SUNDRY NOTICES AND REPORTS ON WELLS (DO NOT USE THIS FORM FOR PROPOSALS TO DRILL OR TO DEEPEN OR PLUG BACK TO A DIFFERENT RESERVOIR. USE "APPLICATION FOR PERMIT" (FORM C-101) FOR SUCH PROPOSALS.)		WELL API NO. 30-025-37522

2. Name of Operator GREAT WESTERN DRILLING COMPANY		6. State Oil & Gas Lease No.
3. Address of Operator P.O. BOX 1659 MIDLAND, TEXAS 79702		7. Lease Name or Unit Agreement Name: DEVON "29" COM.

11. Check Appropriate Box to Indicate Nature of Notice, Report or Other Data	
NOTICE OF INTENTION TO:	SUBSEQUENT REPORT OF:
PERFORM REMEDIAL WORK <input type="checkbox"/> PLUG AND ABANDON <input type="checkbox"/>	REMEDIAL WORK <input type="checkbox"/> ALTERING CASING <input type="checkbox"/>
TEMPORARILY ABANDON <input type="checkbox"/> CHANGE PLANS <input type="checkbox"/>	COMMENCE DRILLING OPNS. <input type="checkbox"/> PLUG AND ABANDONMENT <input type="checkbox"/>
PULL OR ALTER CASING <input type="checkbox"/> MULTIPLE COMPLETION <input type="checkbox"/>	CASING TEST AND CEMENT JOB <input type="checkbox"/>
OTHER: ADD HIGH PRESSURE B.O.P. <input type="checkbox"/>	OTHER: <input type="checkbox"/>

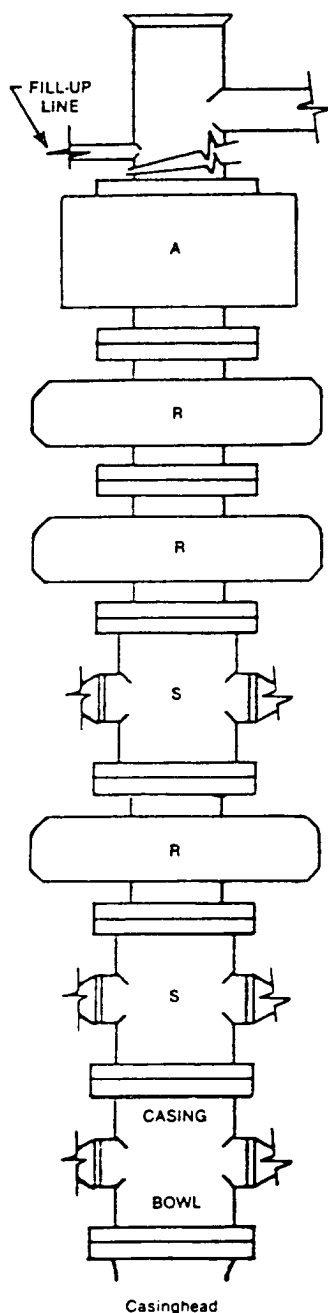
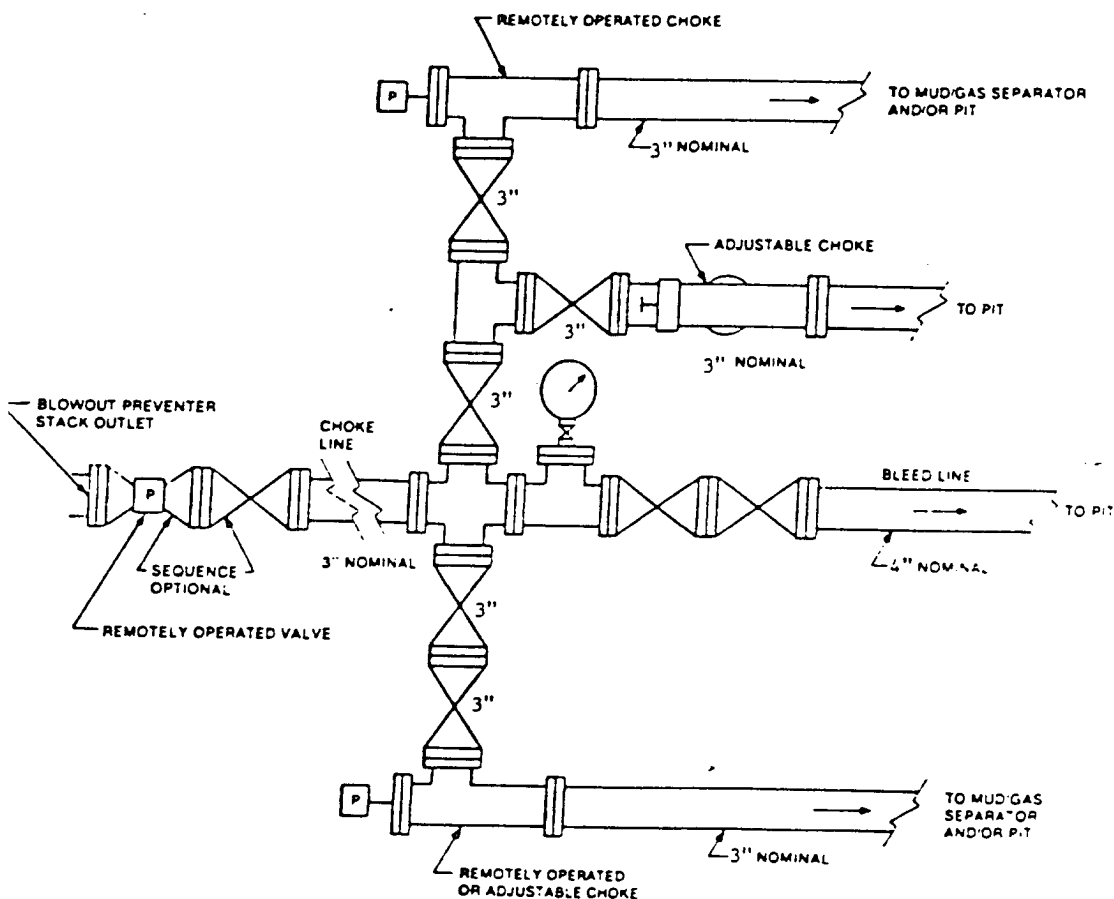
1. After 7" casing is run and set at 13,500' a 10,000 PSI B.O.P. and choke manifold will be installed on the 7" casing, to replace the 5000 PSI equipment.
